CARBON CAPTURE AND SEQUESTRATION PROTOCOL UNDER THE LOW CARBON FUEL STANDARD

New deletions and additions to the originally proposed Carbon Capture and Sequestration Protocol under the Low Carbon Fuel Standard (published on March 6, 2018 as Appendix B to the Initial Statement of Reasons) that are made public with the "Notice of Public Availability of Modified Text and Availability of Additional Documents and Information" are shown in ~~strikethrough~~ and <u>underline</u> tracked changes format, respectively.

June 20, 2018

~~**Figure 1.** An example of geologic sequestration project indicating SSRs.[3]~~

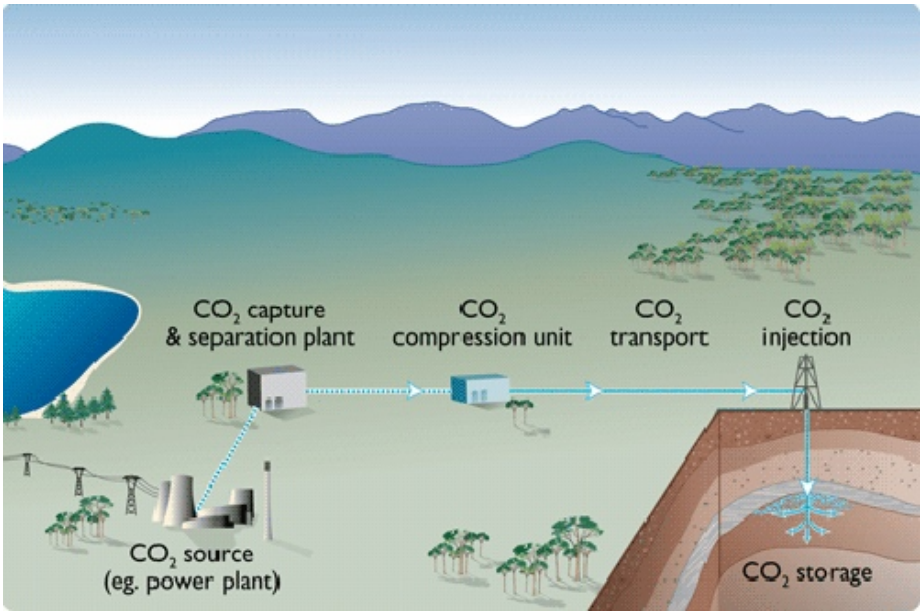
The Accounting Requirements for CCS delineate a system boundary that covers all CO_2 sources, sinks, and reservoirs (SSRs) from a CCS project. All SSRs within the system boundary must be accounted for when quantifying emissions reductions from CO_2 sequestration. ~~Typically, SSRs included in the system boundary are carbon capture and compression, CO_2 transport, and CO_2 injection. Note that the injection and storage (or sequestration) site may be geographically separate from the capture site as shown in Figure 1.~~

Figure 1. System boundary for CO_2 capture and sequestration in oil and gas reservoirs used for CO_2-EOR.

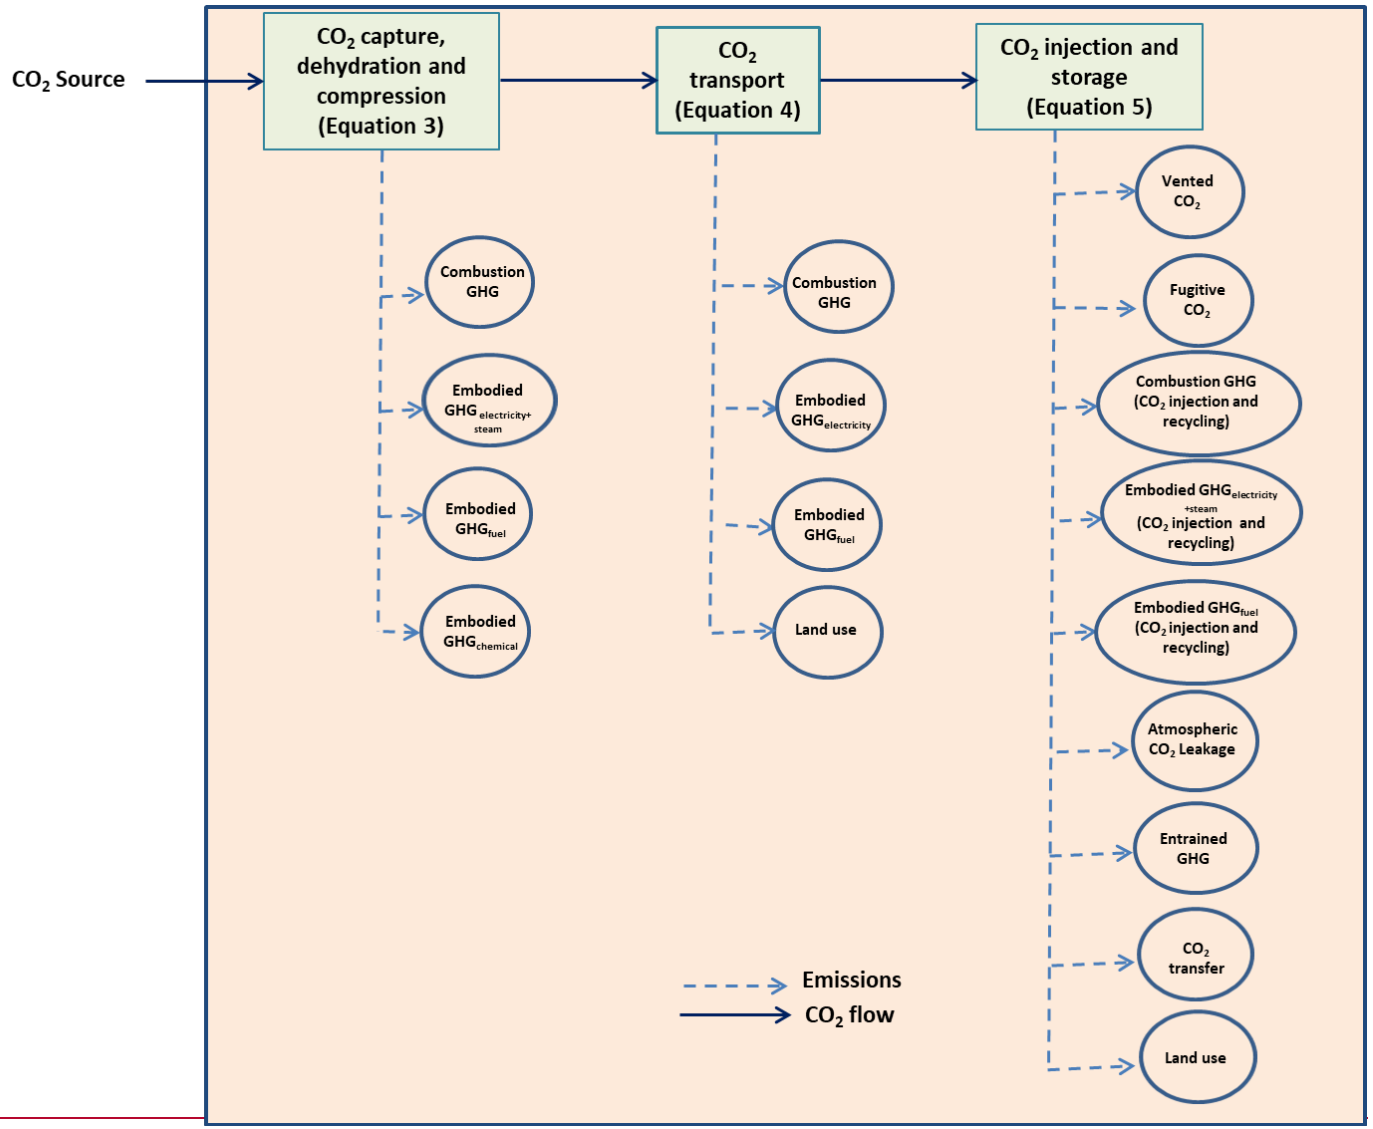
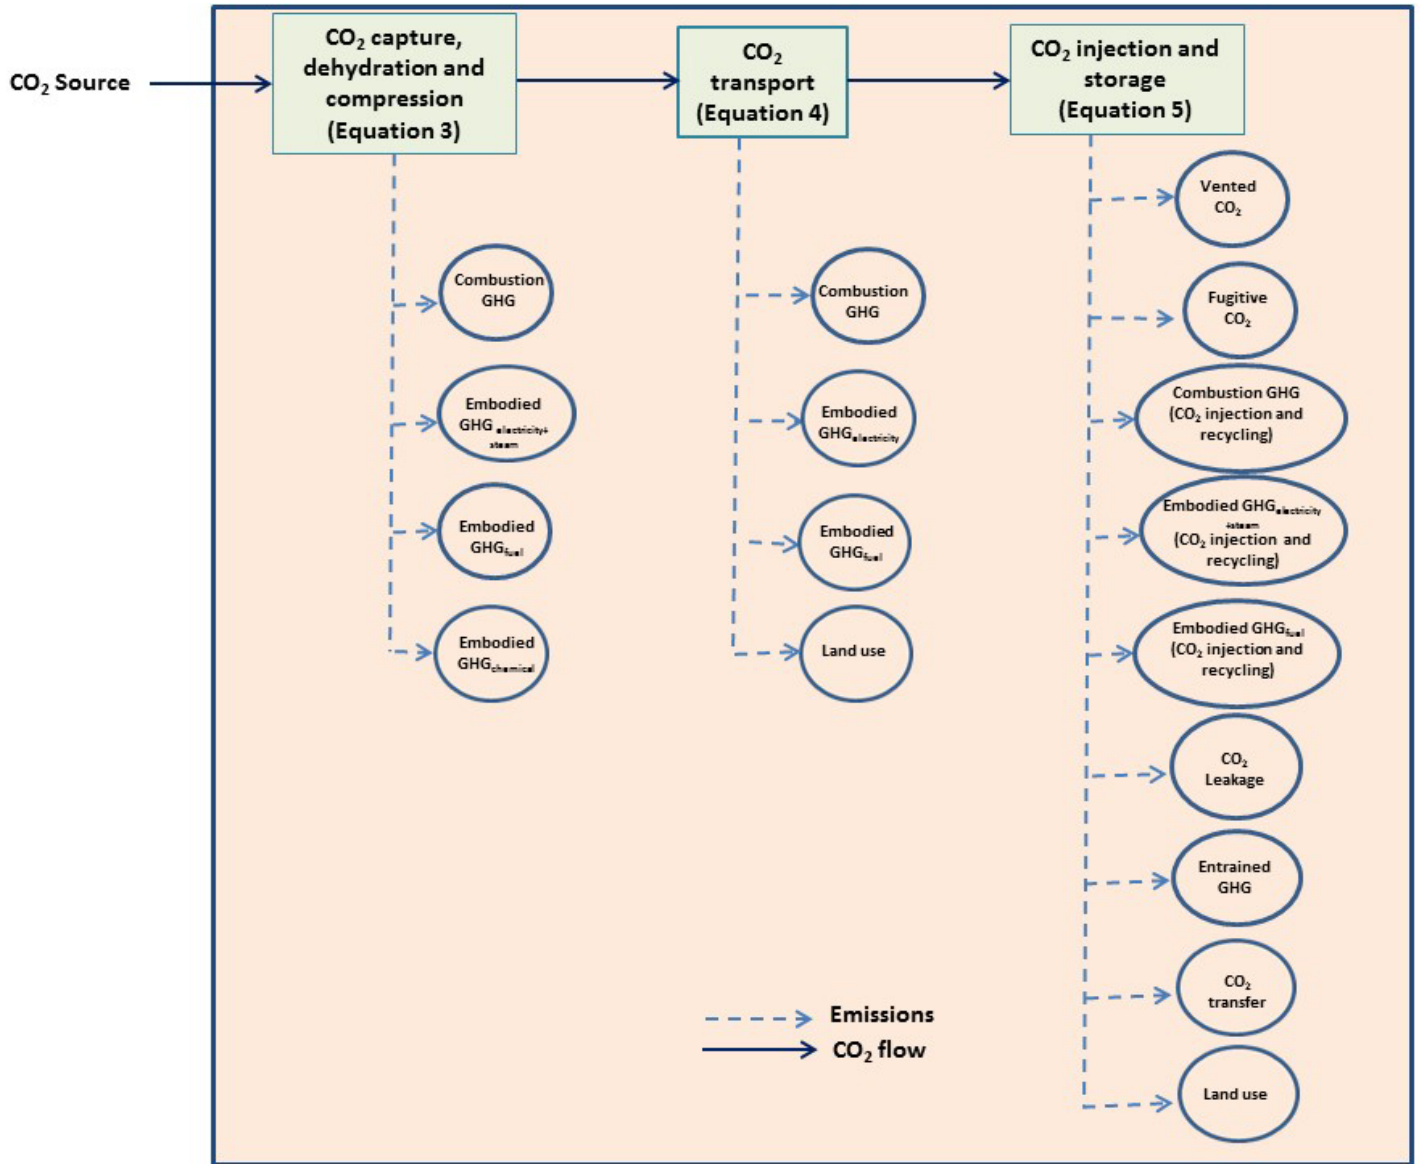
The specific types of equipment and sources covered by the system boundary can vary by CCS project types. Figure 1~~2~~ shows the system boundary for capturing CO_2 and sequestering it in oil and gas reservoirs used for CO_2-EOR indicating which SSRs are included. ~~Likewise,~~ Figure 2~~3~~ shows the system boundary for capturing CO_2 and sequestering it in depleted oil and gas reservoirs and saline formations.

Figure 3. ~~Application process flow diagram~~CCS Protocol certification, operation, and closure process.

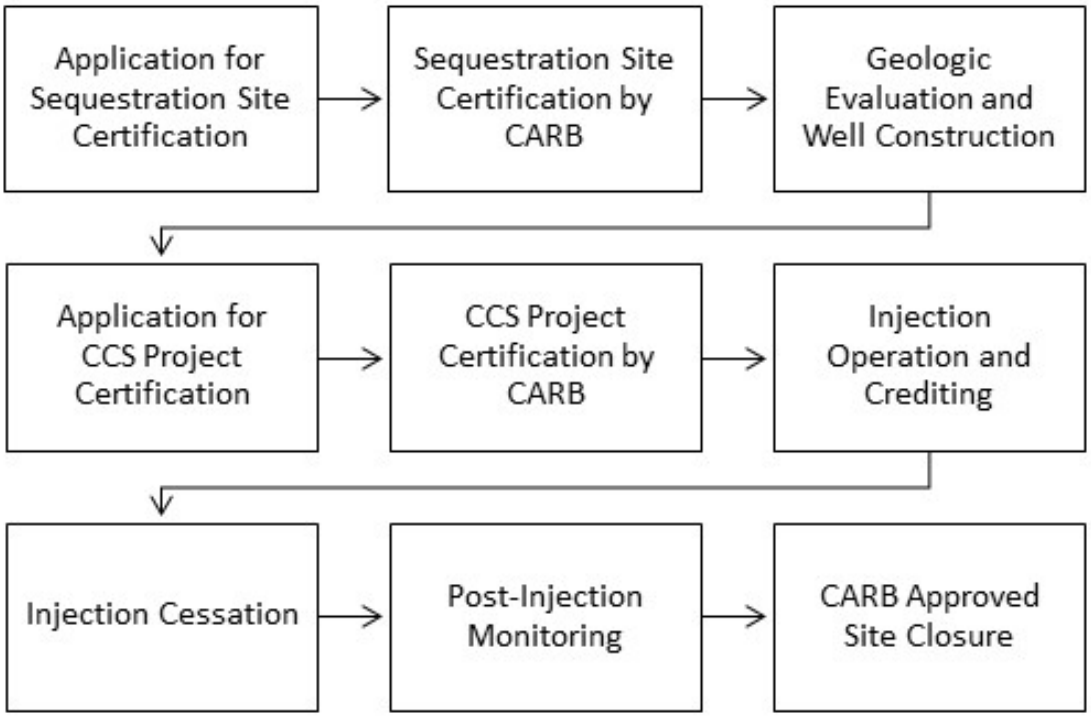
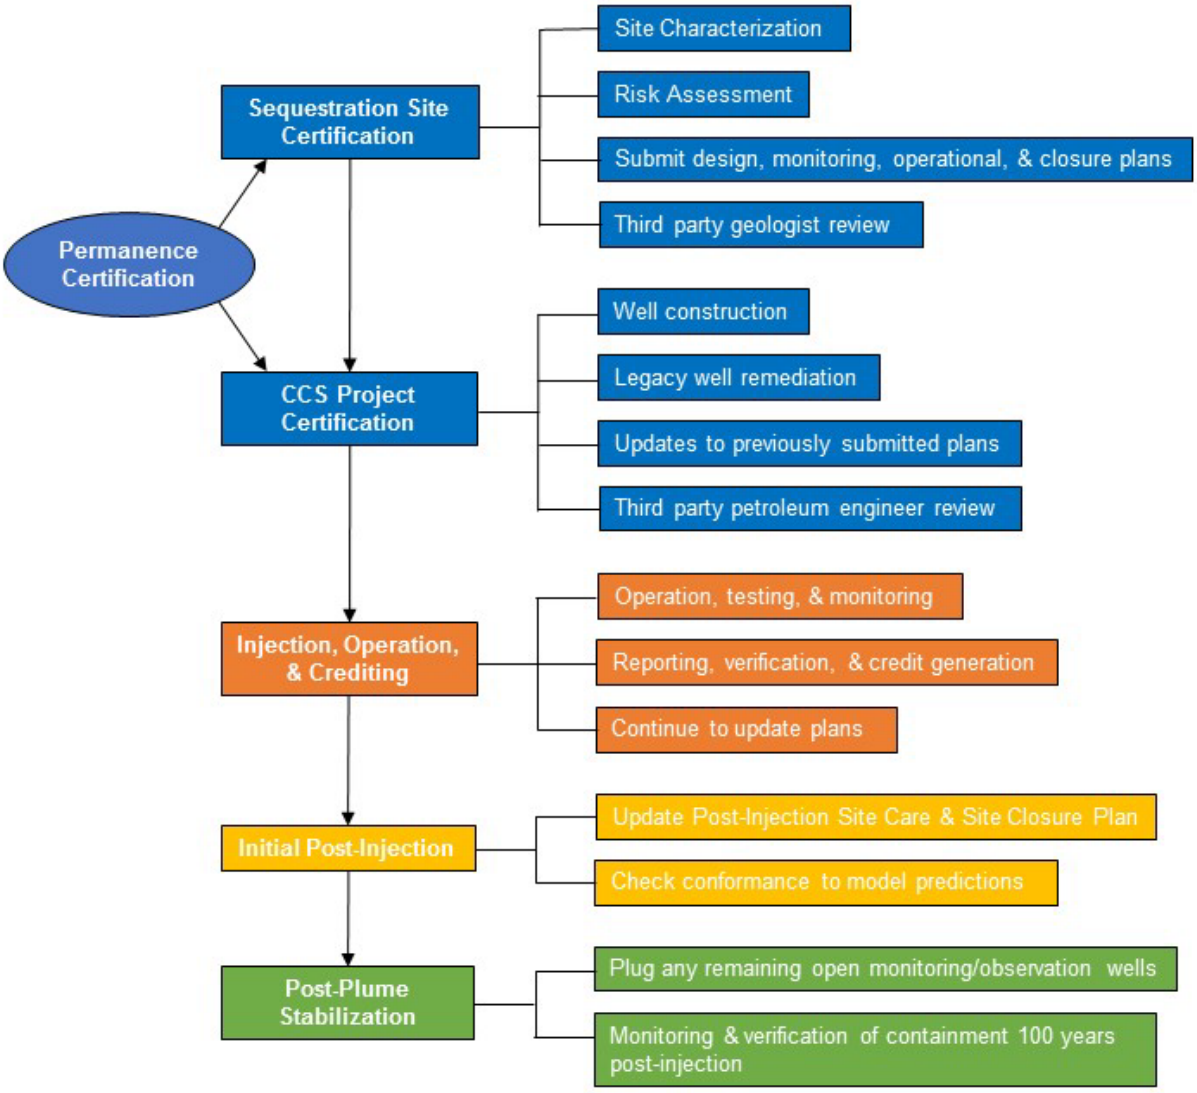
(a) A CCS Project Operator ~~may~~ must apply for Sequestration Site Certification pursuant to subsection C.1.1.2(b) and CCS Project Certification following subsection C.1.1.2(d), which are collectively called Permanence Certification. ~~The Permanence Certification is given to CCS Project Operators when they show, via for aforementioned Site and CCS Project Certifications, that their CCS project is capable of permanent carbon sequestration pursuant to the Permanence Requirements of this Protocol.~~ The application must include the third-party review, data, and plans specified in subsections C.1.1.1 and C.1.1.2. A flow diagram depicting the application process for a typical CCS project is shown in Figure ~~4~~3, below.

Figure 4. Flow chart ~~of~~ showing the process ~~monitoring and modeling~~ for ~~a~~ CCS project design.

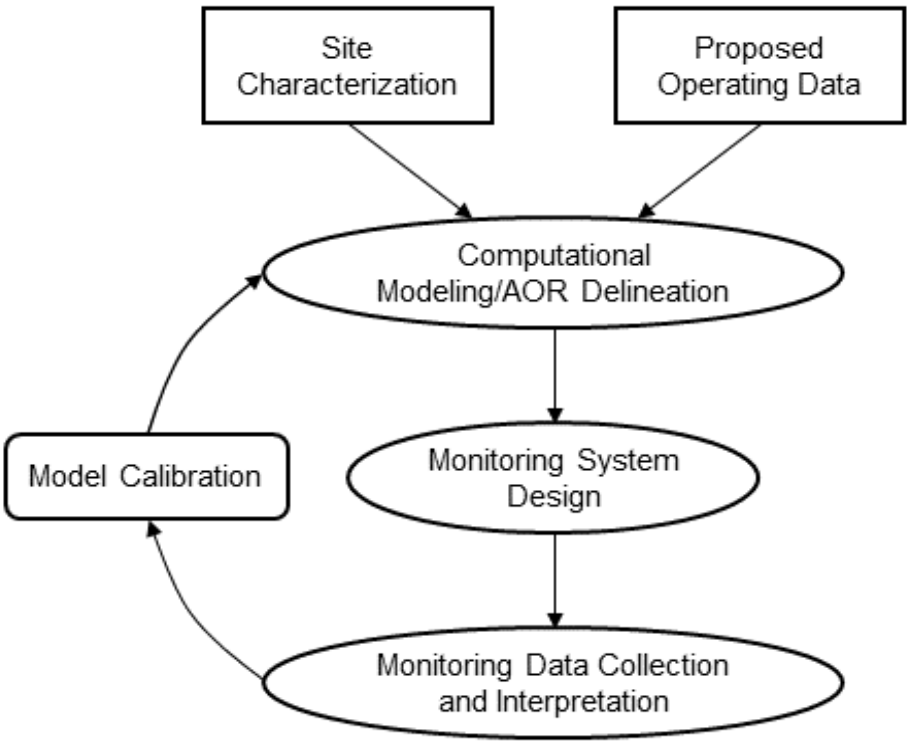
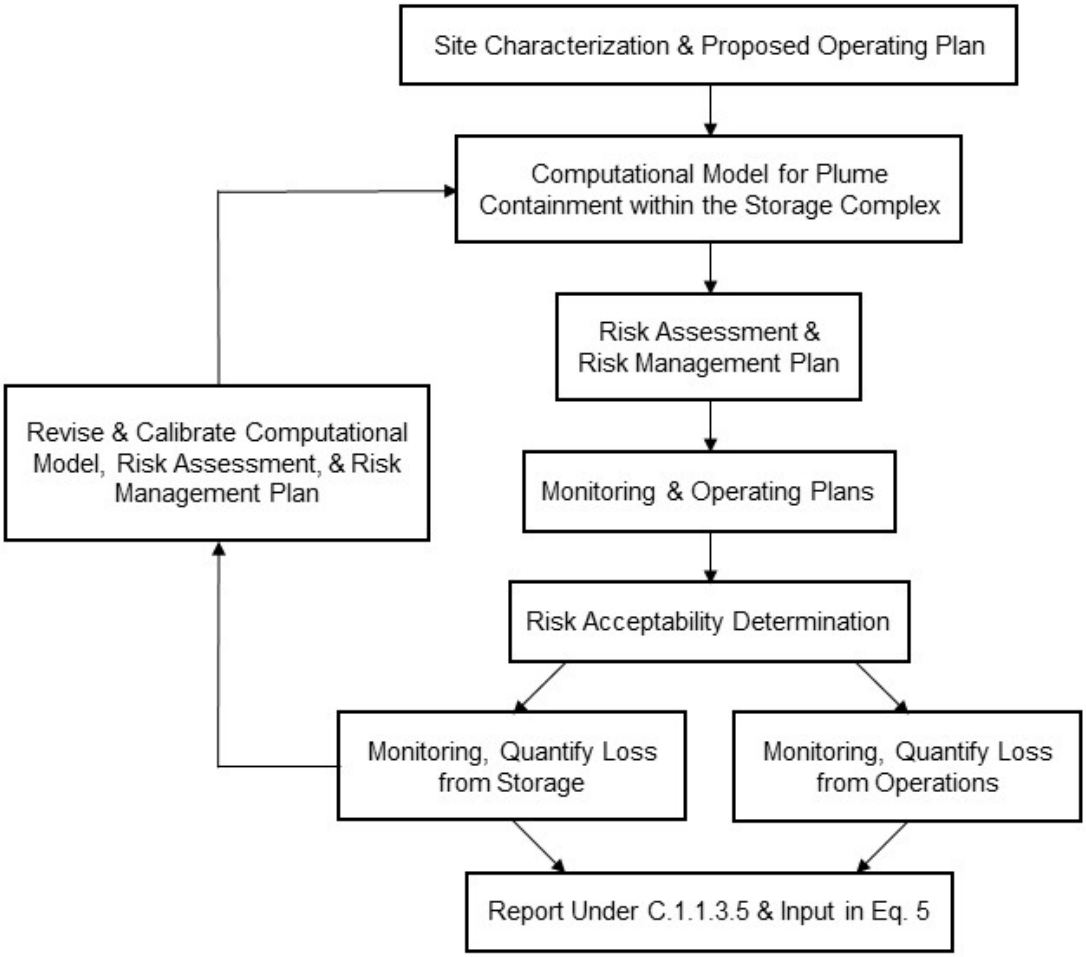
(a) The ~~AOR~~ storage complex delineation and corrective action requirements are to ensure that the surface areas and subsurface volumes potentially impacted by a proposed GSC project are delineated, all wells that need corrective action receive it, and that this process is updated throughout the active life of the CCS project. The general relationship between site characterization, risk assessment, modeling, ~~and~~ monitoring, risk management, quantification, and reporting activities at a CCS project is shown on Figure 4.
